FIELD OBSERVATION REPORT

Central Hardin High School – Phase 2, 2019111 -CA8

Report No: 18

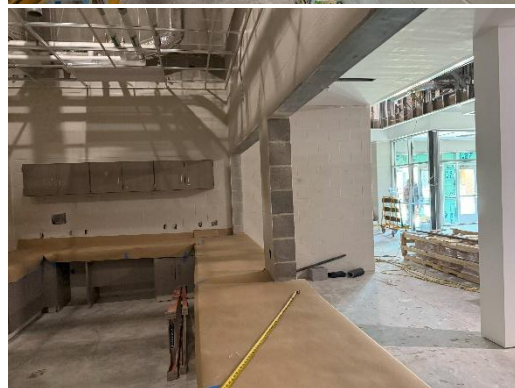
- g) Floor and wall tile had been installed in the girls toilet in Area D. It was difficult to see the condition of the tile due to the lighting and it appeared that it had not been cleaned.
